Project	<b>IEEE 802.16 Broadband Wireless Access Working Group</b> < <a href="http://ieee802.org/16">http://ieee802.org/16</a> >	
Title	<b>Structure and notation enhancements to IEEE P802.16h/D3</b>	
Date Submitted	<b>2007-11-15</b>	
Source(s)	Paul Piggin NextWave Broadband Inc. 12670 High Bluff Drive San Diego CA 92130 USA	Voice: 1 858 480 3100 Fax: 1 858 480 3105 ppiggin @ nextwave.com
Re:	Letter Ballot #29 of IEEE P802.16h/D3.	
Abstract	There are a number of structural and notional enhancements that should be applied to the IEEE P802.16h/D3 draft.	
Purpose	Ensuring the readability of the draft IEEE P802.16h/D3.	
Notice	<i>This document does not represent the agreed views of the IEEE 802.16 Working Group or any of its subgroups. It represents only the views of the participants listed in the "Source(s)" field above. It is offered as a basis for discussion. It is not binding on the contributor(s), who reserve(s) the right to add, amend or withdraw material contained herein.</i>

# Structure and notation enhancements to IEEE P802.16h/D3

[Figure h x1x—The relationship between frame boundaries and the DMA algorithm](#)

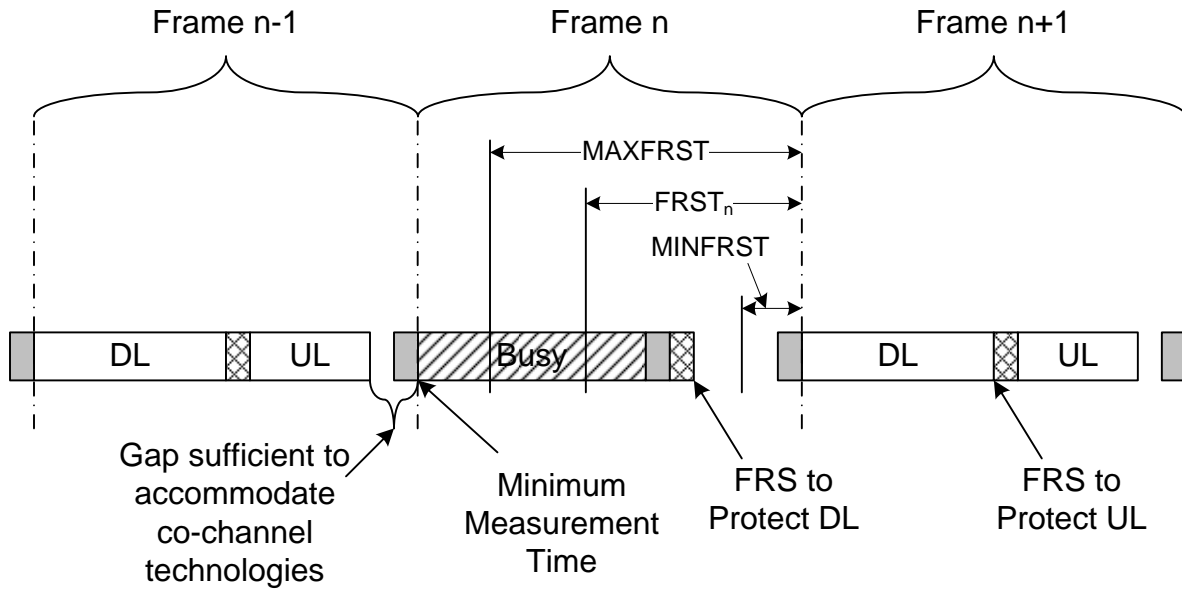
The relationship between frames boundaries and the DMA algorithm is shown in [Figure h x1x](#); The [DMA algorithm timing](#) parameters are applied as shown in [Figure h 19](#).

**Figure h19—Reclaiming the Medium Timing parameters of the DMA algorithm**

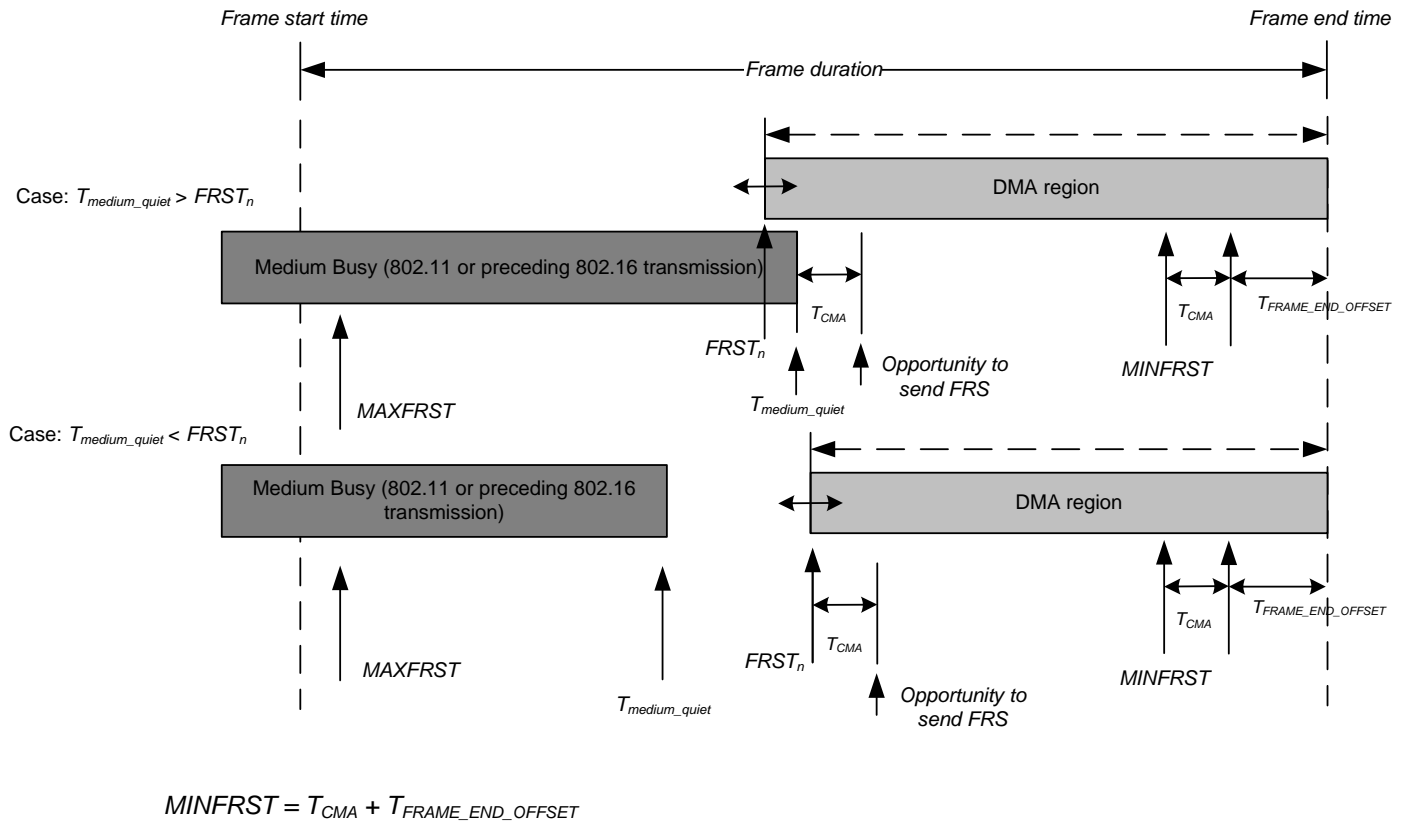
Replace [Figure h19](#) in [1] ‘Reclaiming the Medium’ with the following. Also make the caption changes as shown.

Figure h21 (a) Downlink FRS

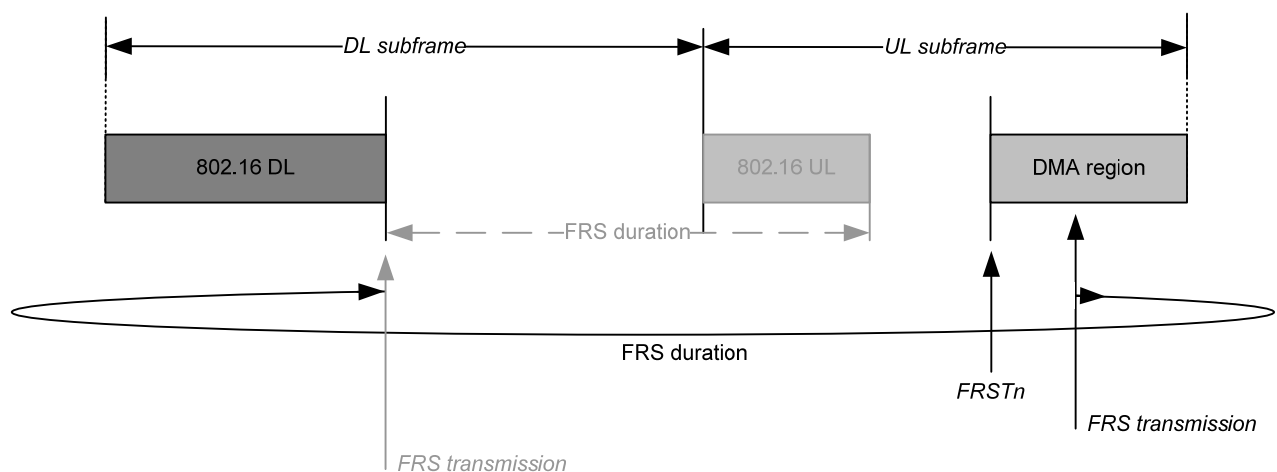
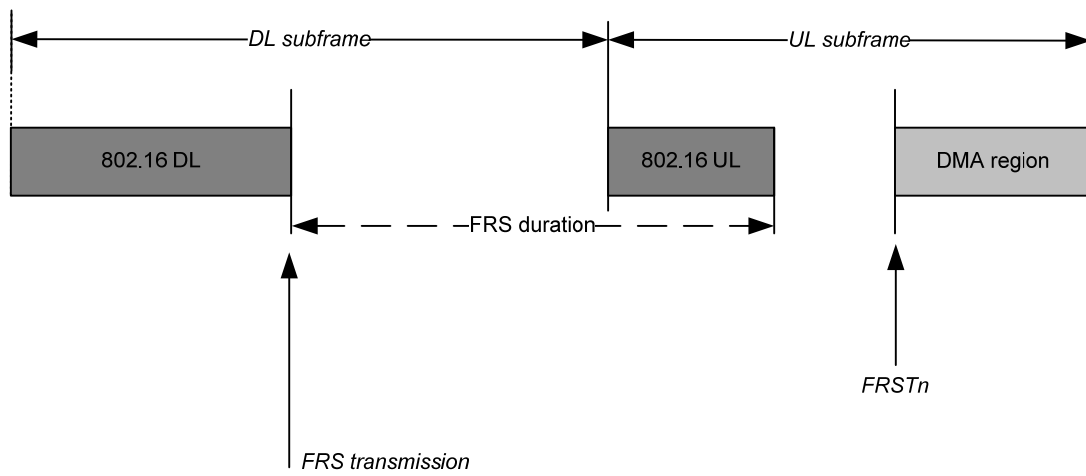
When using any carrier sense protocol, such as LBT, in a wireless environment the hidden node problem cannot be 100% avoided. It can only be mitigated. Additionally, in bands such as 3.65 GHz in the US, there is an aggravated hidden node problem due to the distinctly lower transmit power allowed for mobile devices compared to fixed, registered devices. The mobiles are more often geographically disadvantaged due to this transmit power disparity. Fixed, registered client devices can also be geographically disadvantaged (the classical hidden node problem), although not as often. To remedy this the BS transmits a Frame Reservation Signal (FRS) at the end of the DL subframe to reserve the subsequent UL subframe (or used portion, thereof) for the subscriber stations. The BS also transmits an FRS in the DMA region at the time a decision is made to claim the medium. The form of the FRS is band dependent and should be structured to be receivable by other technologies that may be co-channel. For instance, in bands where 802.11 would be a typical co-channel asynchronous system, the 802.11 CTS transmitted using the appropriate 802.11 burst structure would suffice. The reservation of the DL and UL subframe by the BTS precludes the need for the SS to also perform LBT. ~~The use of~~ An example of using the FRS to protect the DL and UL is shown in Figure h 21.

Replace figure h21 with the following.
